HISTORIC AND DESIGN REVIEW COMMISSION

February 05, 2020

HDRC CASE NO: 2020-020
ADDRESS: 1112 E CROCKETT ST
LEGAL DESCRIPTION: NCB 585 BLK 2 LOT 3
ZONING: RM-4, H
CITY COUNCIL DIST.: 2
DISTRICT: Dignowity Hill Historic District
APPLICANT: Anthony Segura II/The Window Source of San Antonio
OWNER: Ricardo Gonzales/GONZALES RICARDO S
TYPE OF WORK: Window replacement
APPLICATION RECEIVED: January 16, 2020
60-DAY REVIEW: March 15, 2020
CASE MANAGER: Huy Pham

Model 3A01 Double Hung

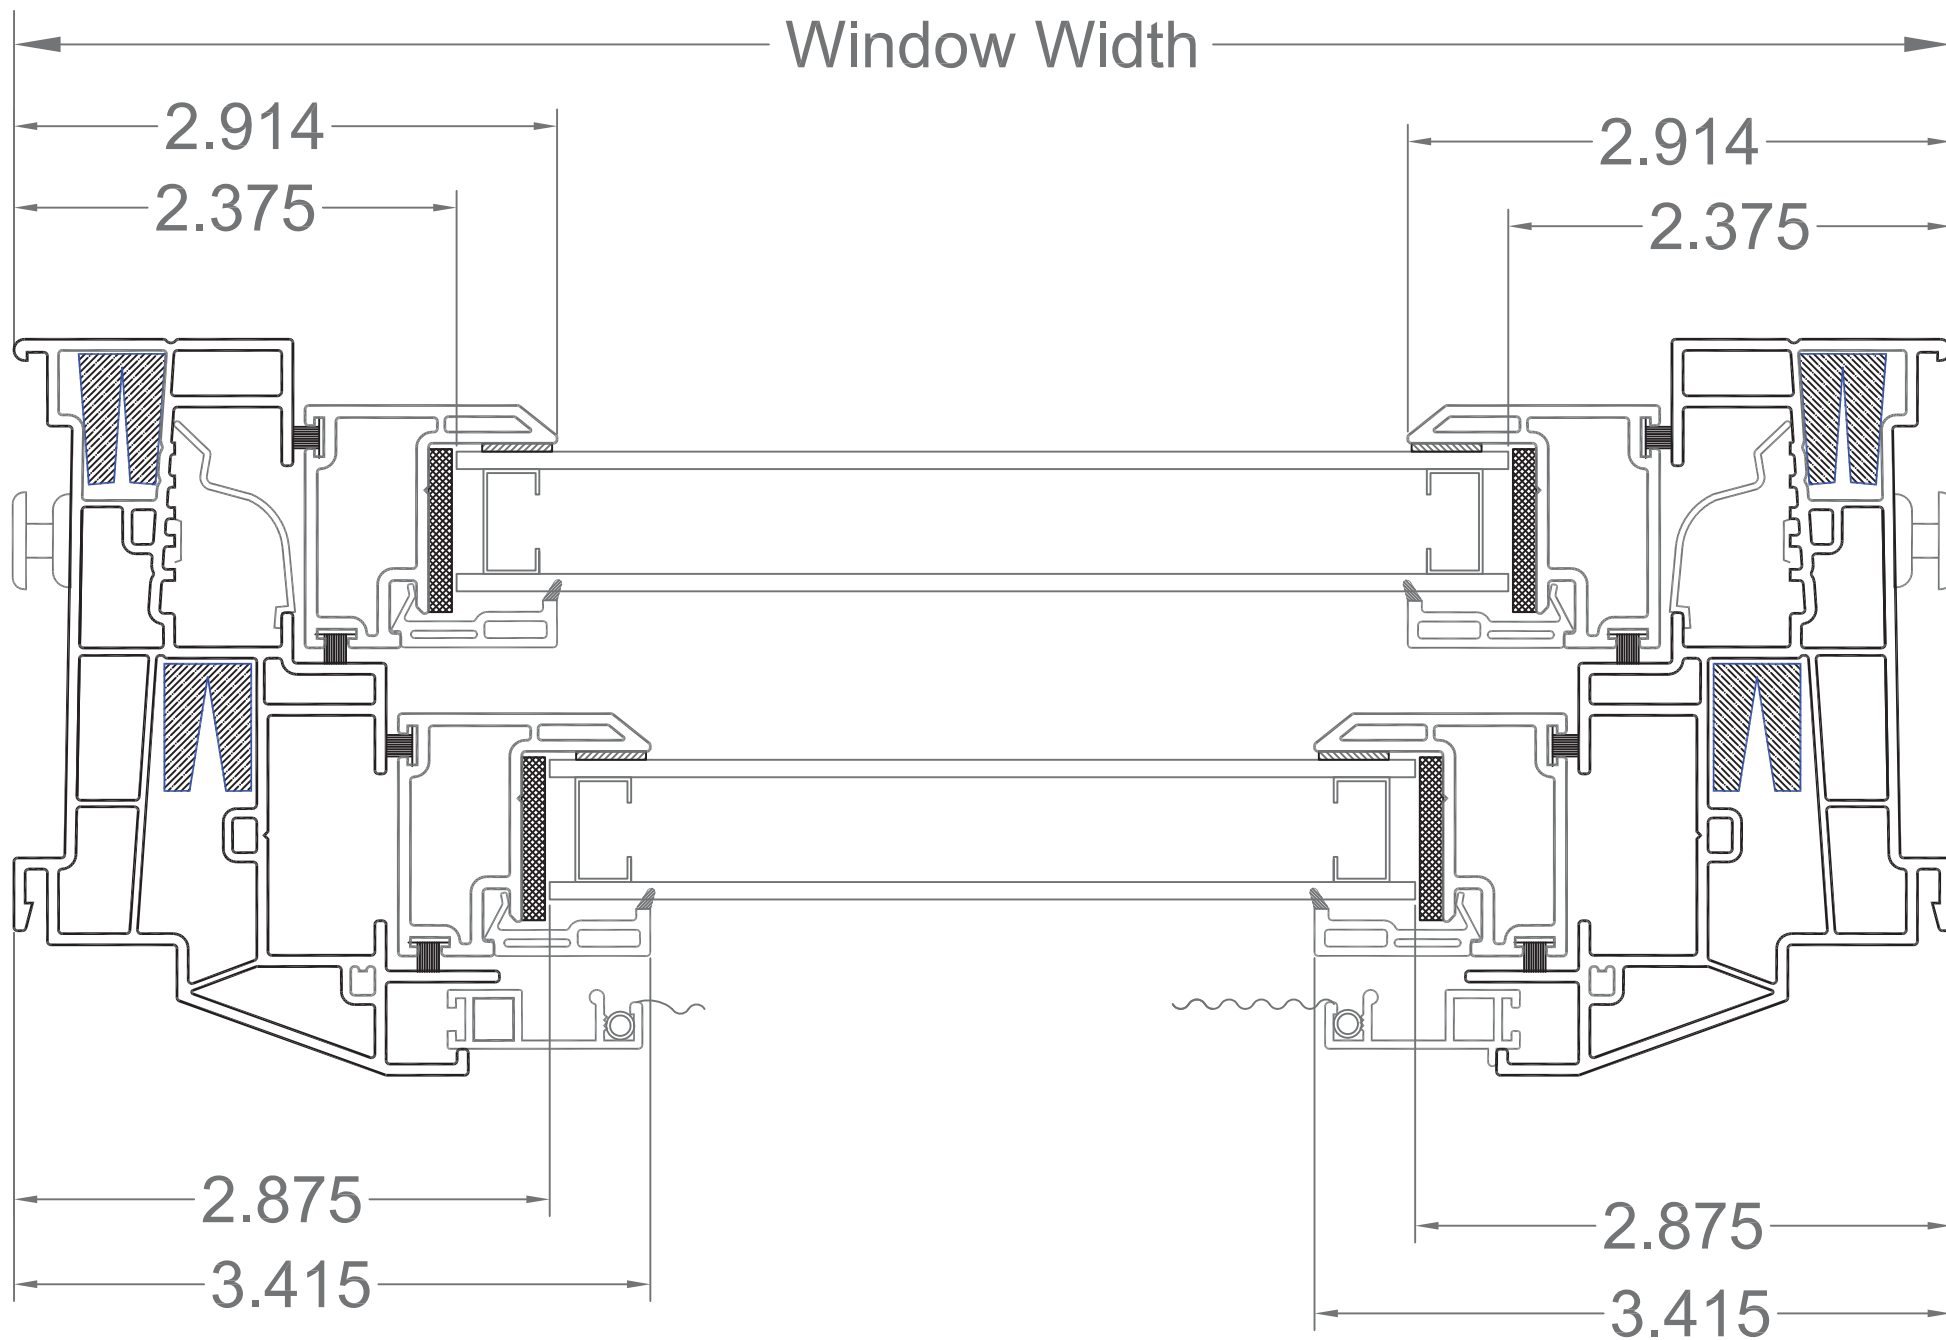
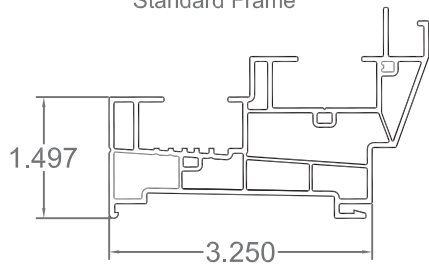
- c. **ADDITION WINDOWS** – The applicant has proposed to replace four vinyl windows on the rear addition with new vinyl windows (Alside 3A01). The applicant has included the use of faux divided lights on two windows to match their existing configuration. Staff finds the existing vinyl windows are not original to the historic structure, and are eligible for replacement if the new windows are an improvement upon the overall quality and conformity to the historic structure, which excludes the continued use of faux divided lights or nailing fin installations. Staff finds that the proposed windows should otherwise meet the Standard Specifications for Windows in Additions and New Construction.

- i. That the new windows exclude faux divided lights and nailing fins, and otherwise adhere to the *Standard Specifications for Windows in Additions and New Construction*.
- ii. That the new glass on the picture and transom windows are plain and clear, and that there will be no alterations to the existing wood window frames.
- iii. That all unapproved work within the last two years are remedied with approval or reversal including:
 - a. Restoring the front door to feature a Folk Victorian style door.
 - b. Restoring the decorative gable returns on the front-facing and turned gabled roofs.

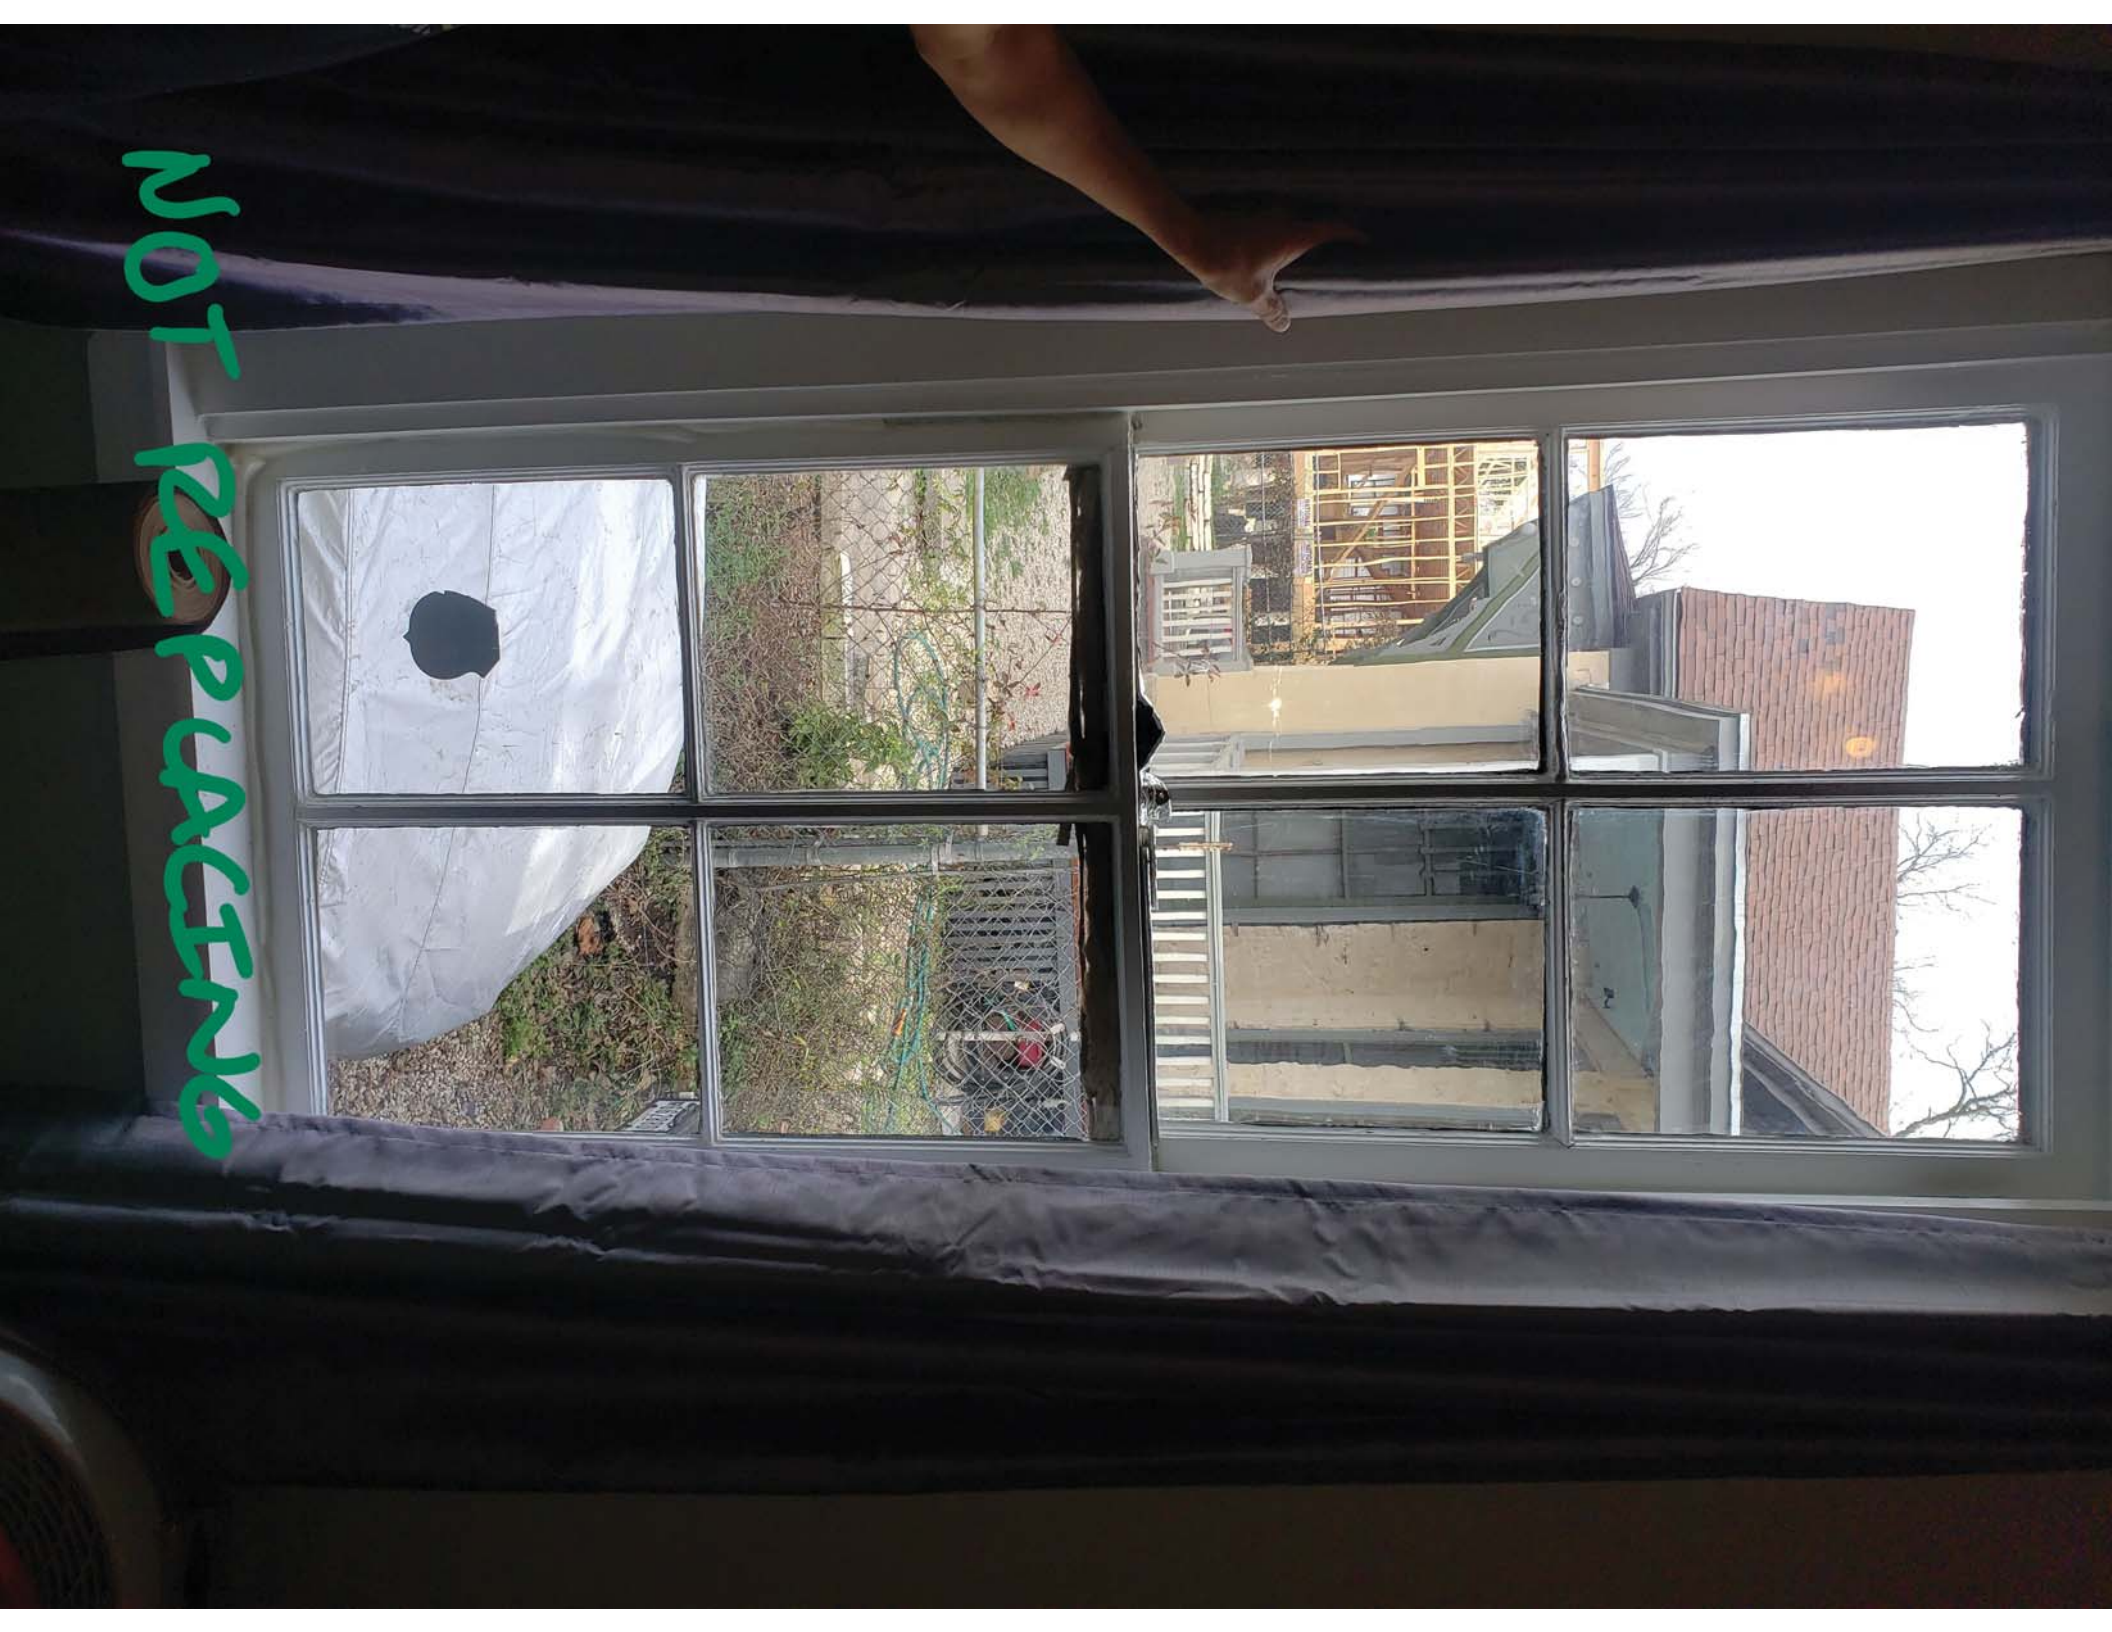
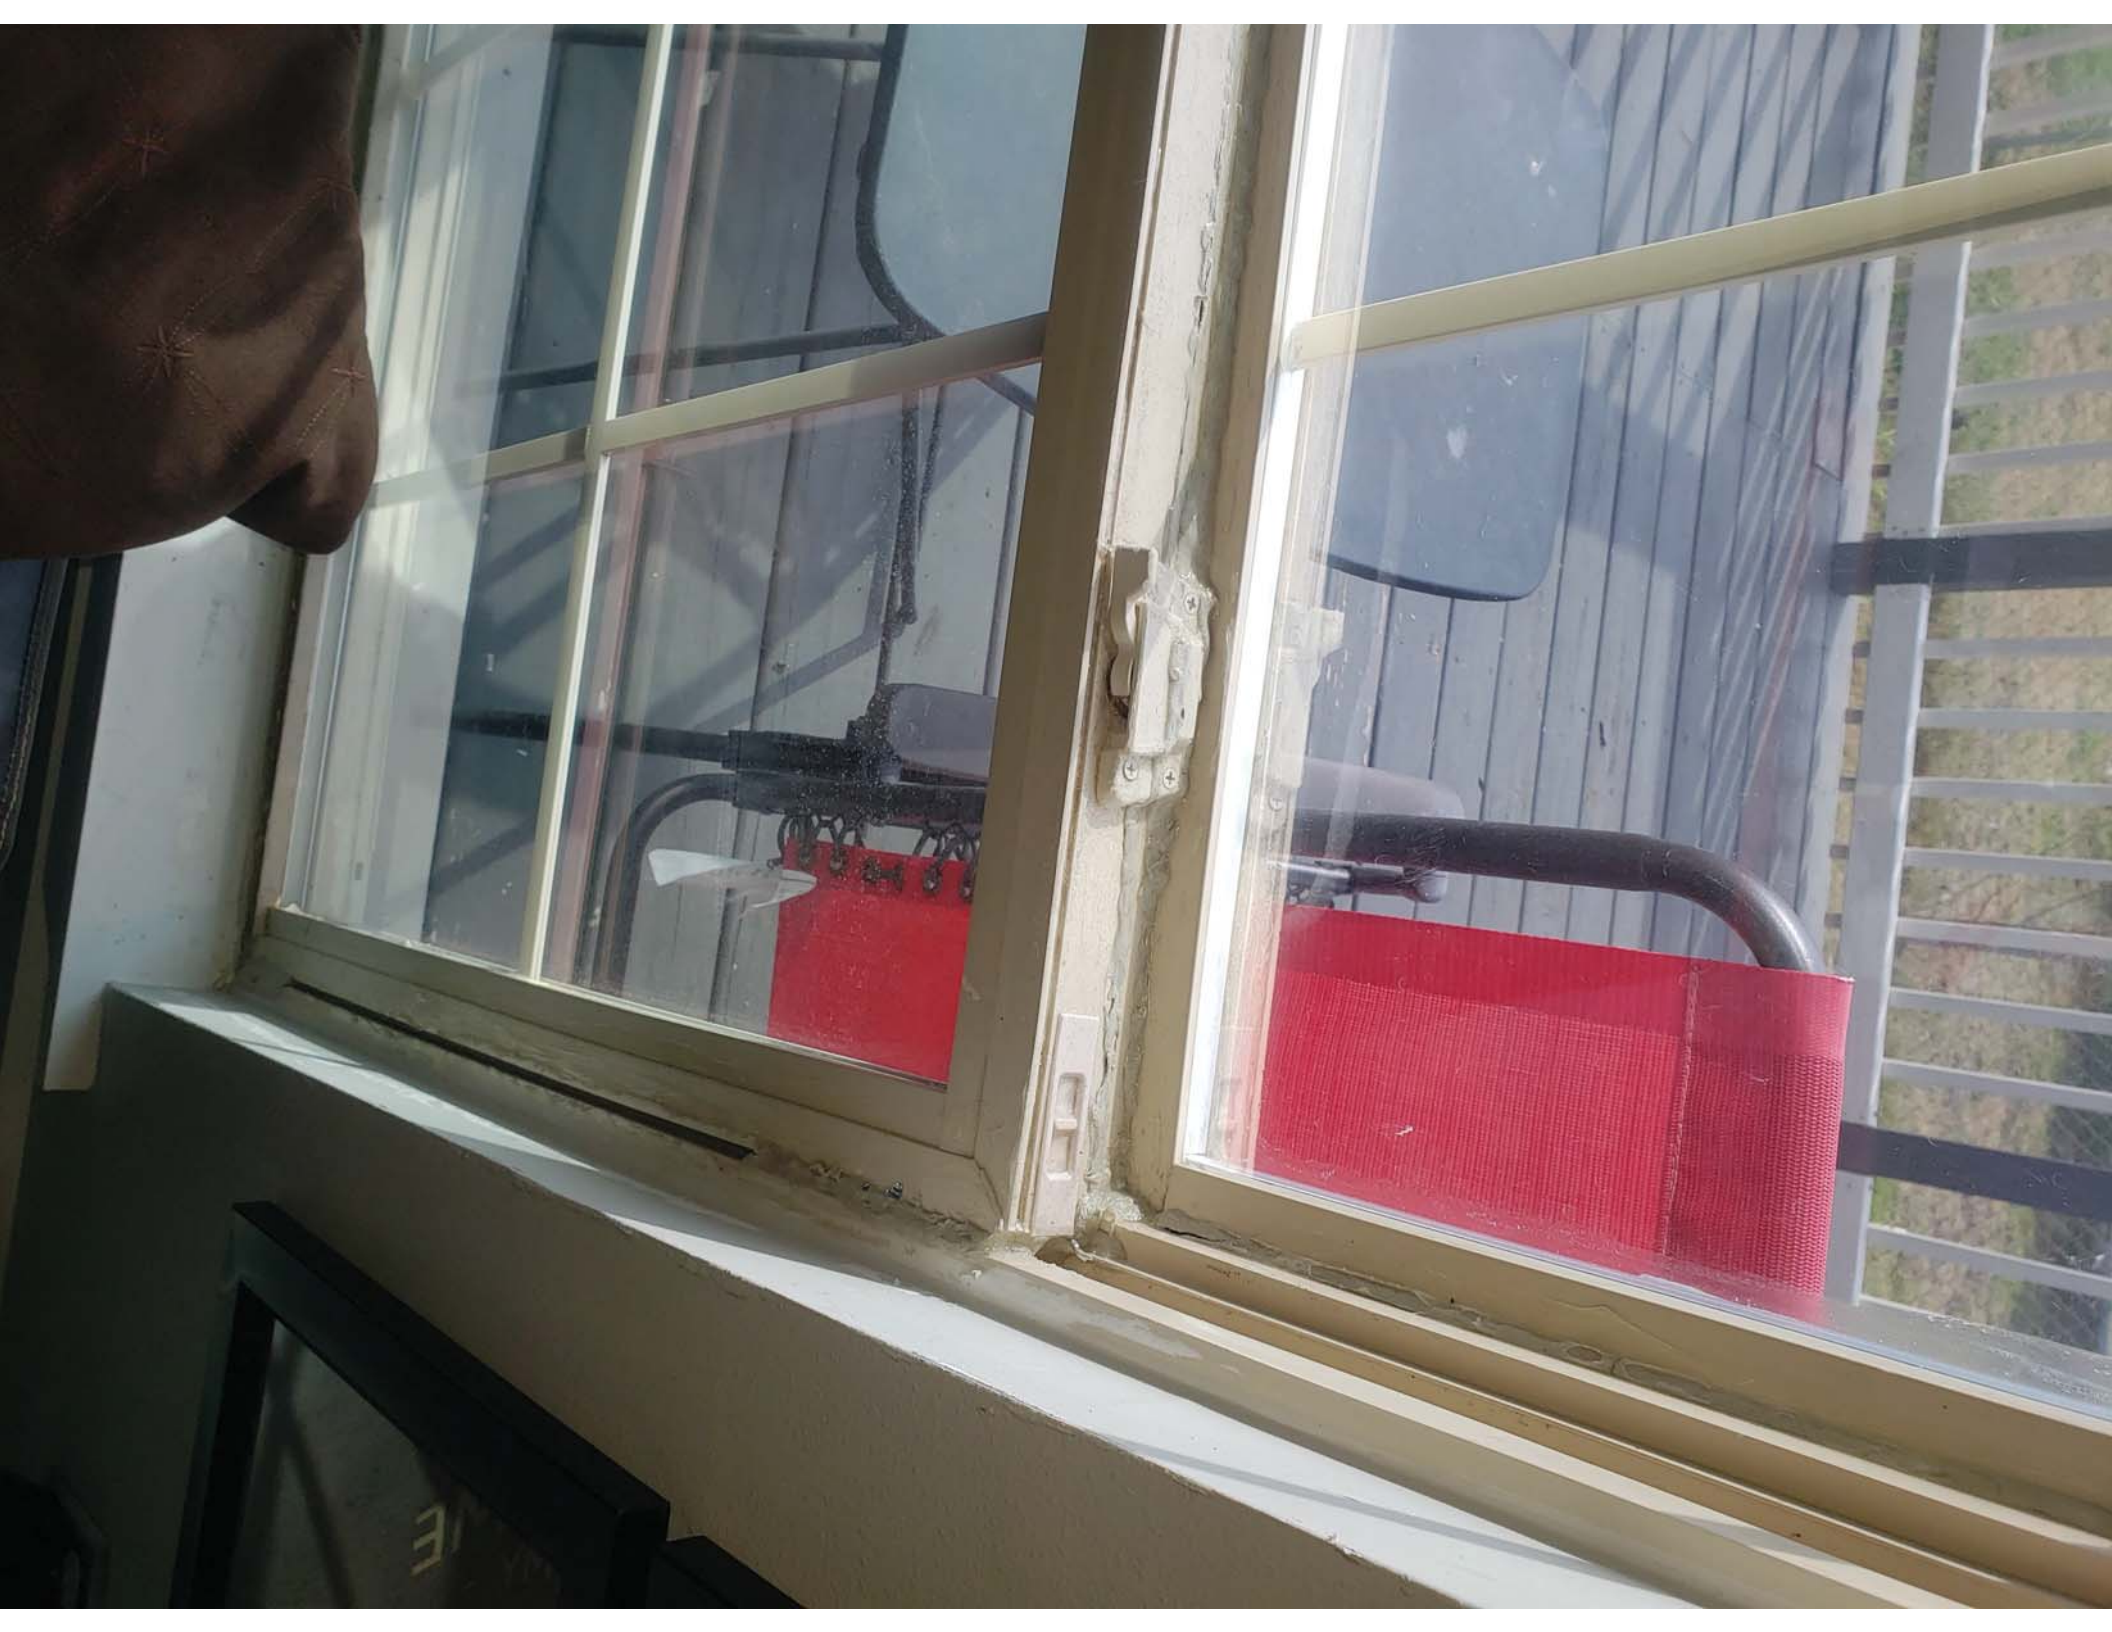
- d. **PICTURE AND TRANSOM WINDOWS** – The applicant has proposed to replace the glass of two picture windows and one transom window. Per the Guidelines for Exterior Maintenance and Alterations 6.B.vi., applicants should use clear glass when replacement of glass is necessary, not use tinted glass, reflective glass, opaque glass, and other non-traditional glass types unless it was used historically. Staff finds that the proposed glass replacement is generally appropriate if plain clear glass is used and there are no alterations to the wood window frames.
